11/14/242/HQ-D / Campaign code	!	Author: AHE	February 20th 2014
Applies to:	Crimping of the wiring harness		
Model:	1190 ADVENTURE/ R/ WES model year 2014 1290 Super Duke R model year 2014		
Restrictions:	The VINs of affected motorcycles have a link on Dealer.net		
Countries:	All

Incorrectly crimped cables for the power supply

Figure 1:

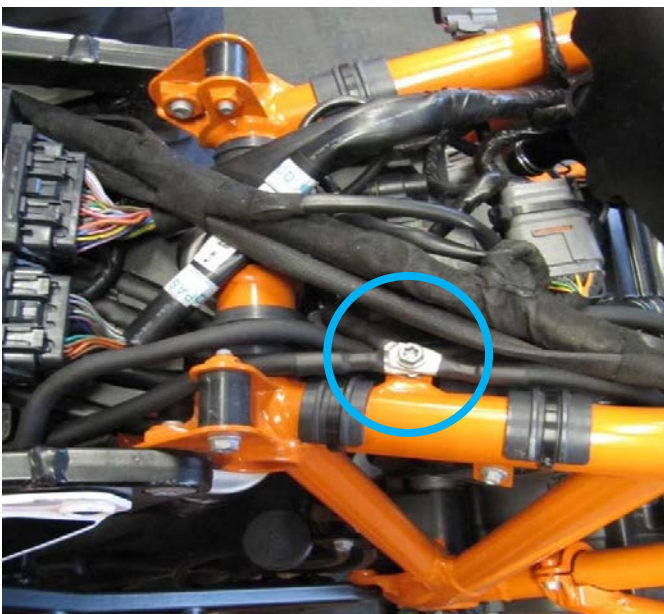
Positive side: From the battery to the starter relay
 From the starter relay to the starter connection

Connections on the starter relay

Figure 5:

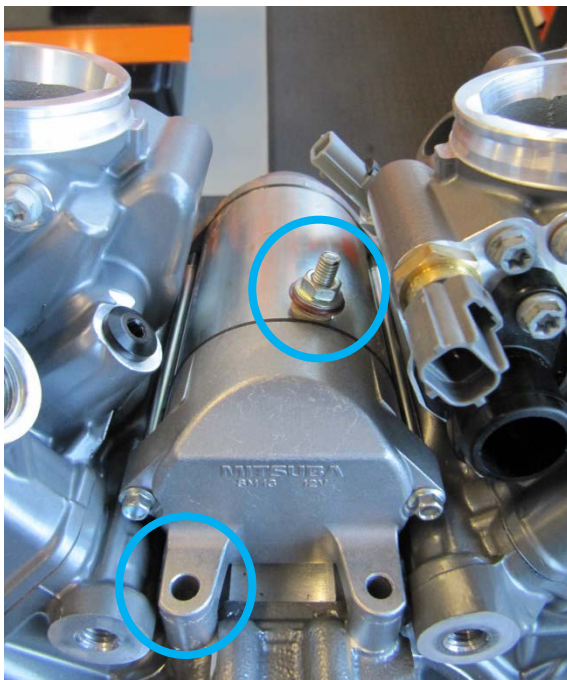
Ground connection on the frame in the area of the upper shock absorber support

Important: Place the contact washer back between the frame and cable.
